**WATTS BAR NUCLEAR PLANT (WBN) – LICENSE AMENDMENT (WBN-TS-03-09) TO REVISE THE TECHNICAL SPECIFICATIONS AND BASES FOR THE DELETION OF THE UNIT 2 VITAL INVERTERS**

TENNESSEE VALLEY AUTHORITY  
WATTS BAR NUCLEAR PLANT (WBN)  
UNIT 1  
DOCKET NUMBER 390

PROPOSED LICENSE AMENDMENT REQUEST WBN-TS-03-09  
DESCRIPTION AND EVALUATION OF THE PROPOSED CHANGE

**Outline of Key Changes Proposed for the Vital AC System**

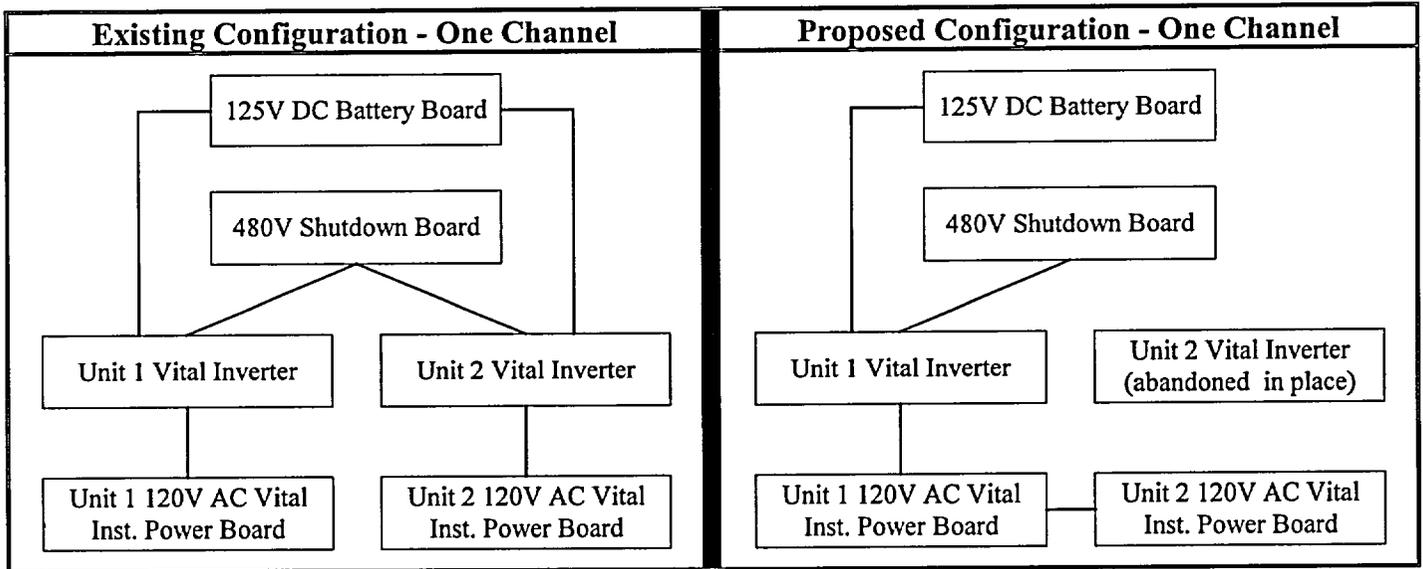
The Unit 2 120V AC Vital Instrument Power Boards presently receive their uninterruptible power supply (UPS) from the Unit 2 120V AC Vital Inverters. The proposed amendment modifies the configuration of the four channels so that each Unit 2 Vital Instrument Power Board receives power from the 120V AC Vital Inverter supplying the associated Unit 1 120V AC Vital Instrument Power Board through the Unit 1 120V AC Vital Instrument Power Board. A simplified diagram of the proposed change is provided below:

**WBN Unit 1 - Vital AC**  
**Proposed Configuration to be implemented During Cycle 5**

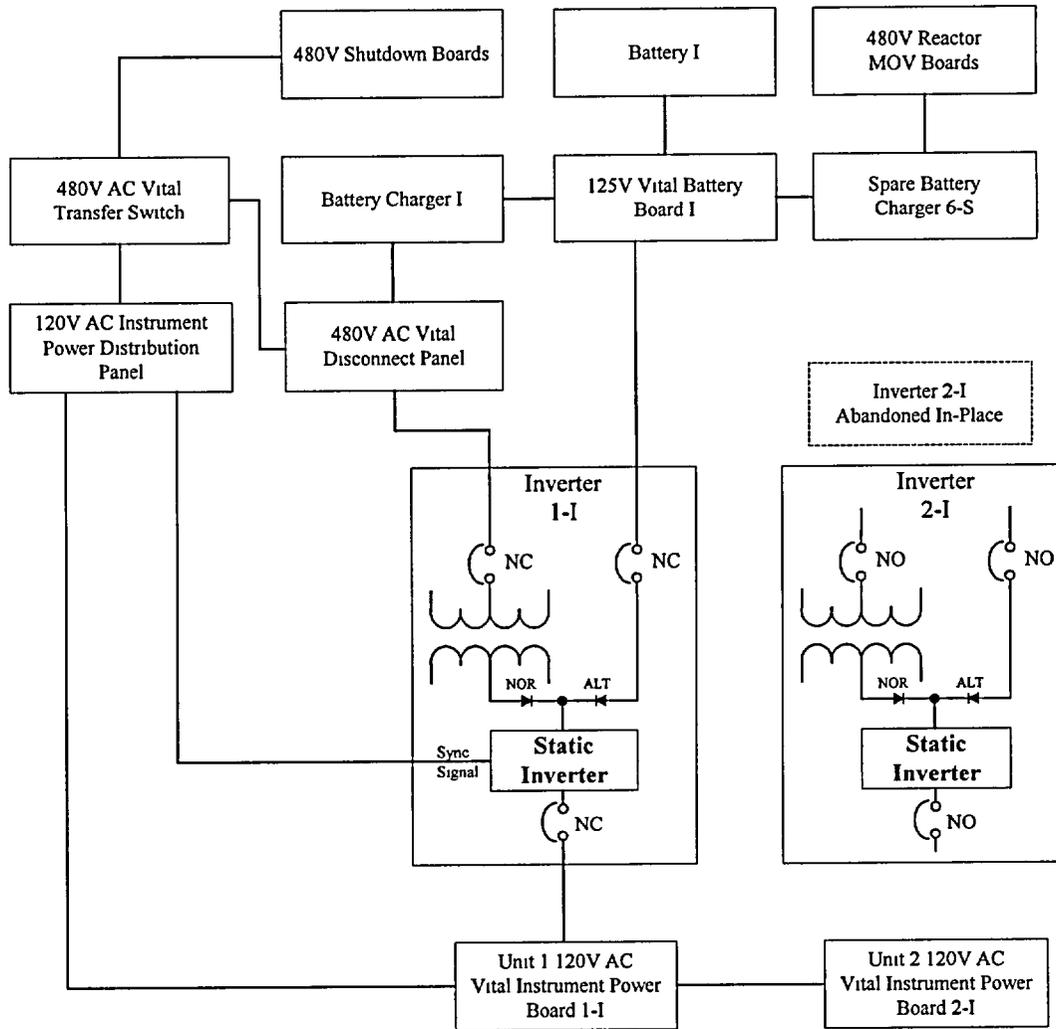
- A. The 480V AC Vital Disconnect Panels will be physically installed in the plant along with the required conduit and cabling. The disconnect panels provide the capability to individually isolate the 480V loads from the transfer switch. This feature improves personnel safety and will facilitate the future replacement of the vital inverters.

- A. The cables for the disconnect panels will be terminated.
- B. The Unit 1 and Unit 2 Vital Instrument Power Boards will be connected together so that the both units are supplied from the Unit 1 inverter.
- C. The Unit 2 inverters will be abandoned in-place.

**WBN Unit 1 - Vital AC  
Configuration to be implemented During Cycle 6 (Conceptual Design)**

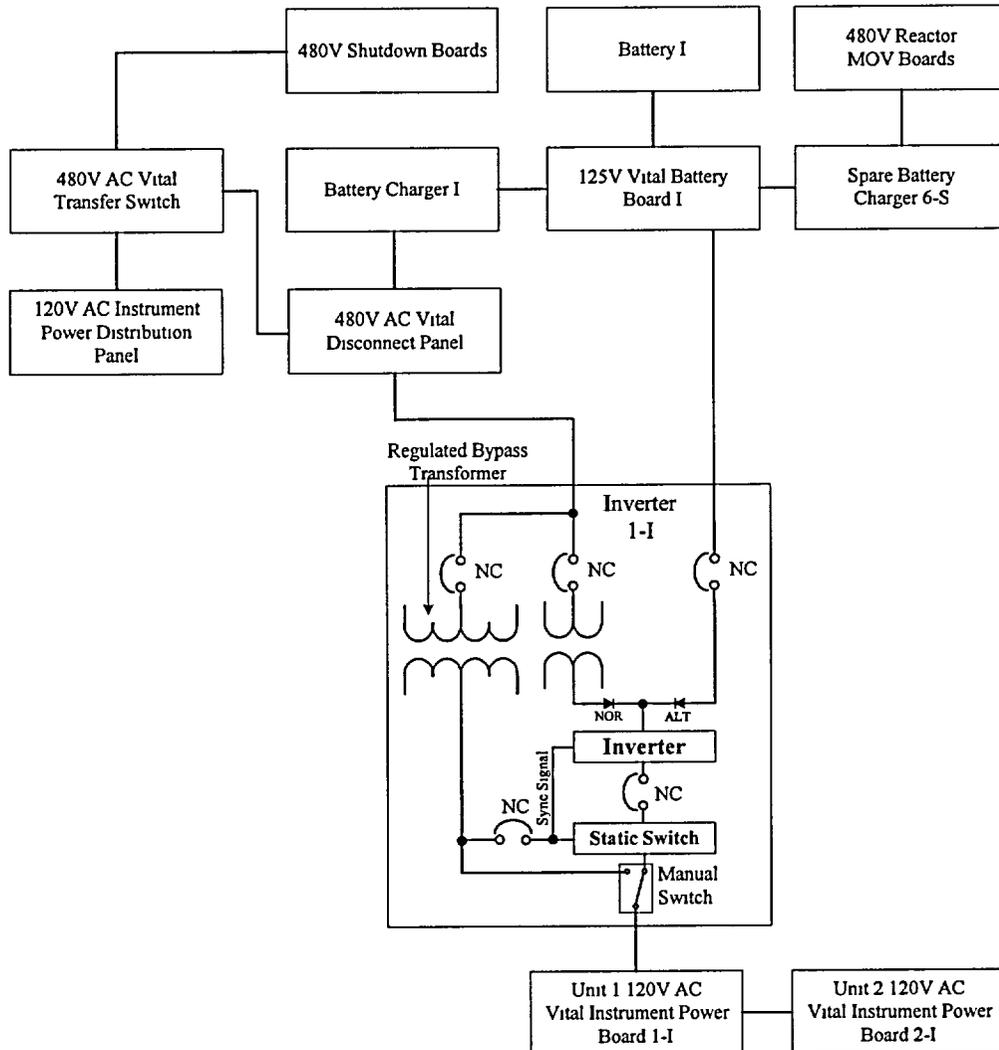
- A. The abandoned Unit 2 inverters will be removed and the new inverters will be installed. The new inverters will have regulated bypass transformers and static switches. The uninterruptible power supply (UPS) output will automatically transfer to the regulated bypass transformer in the event of inverter failure or overload.
- B. Initiate, if required, a license amendment request to address unit operation with the new inverters.

- A. The electrical connections for the old Unit 1 inverters will be removed and the equipment will be abandoned in-place.
- B. The electrical connections for the new inverters will be terminated.
- C. The new inverters will be appropriately tested prior to being placed into service as the Unit 1 inverters.

**WBN Unit 1 - Vital AC  
Configuration to be implemented During Cycle 7 (Conceptual Design)**

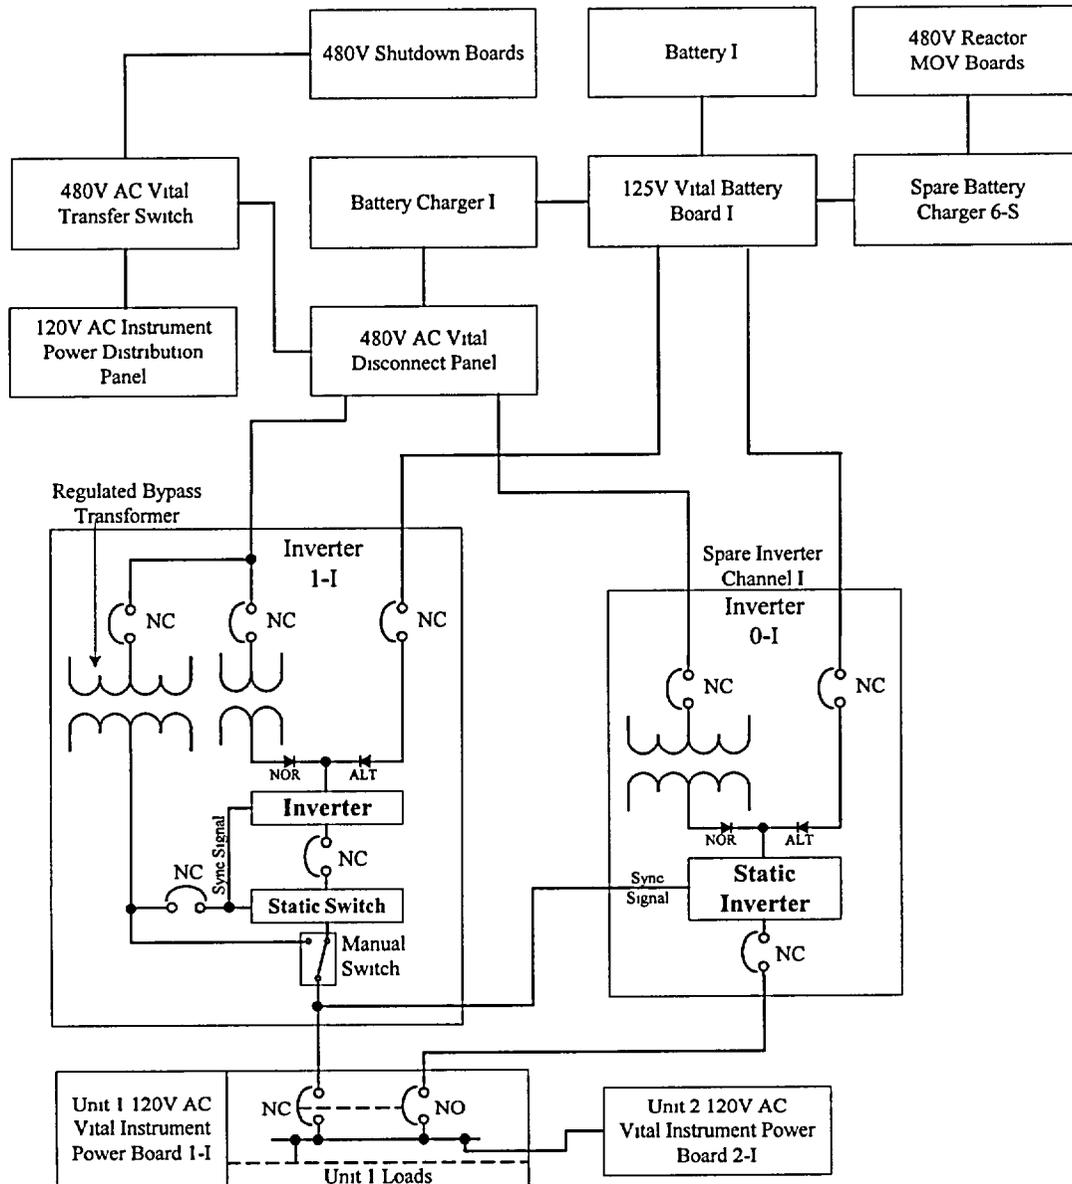
- A. The abandoned old Unit 1 inverters will be removed and new spare inverters will be installed. The new spare inverters will not have static switches or regulating bypass transformers.
- B. Initiate, if required, a license amendment request to address operation of the spare inverters.

- A. The electrical connections for the new spare inverters will be terminated.
- B. The new spare inverters will be appropriately tested prior to being placed into service.
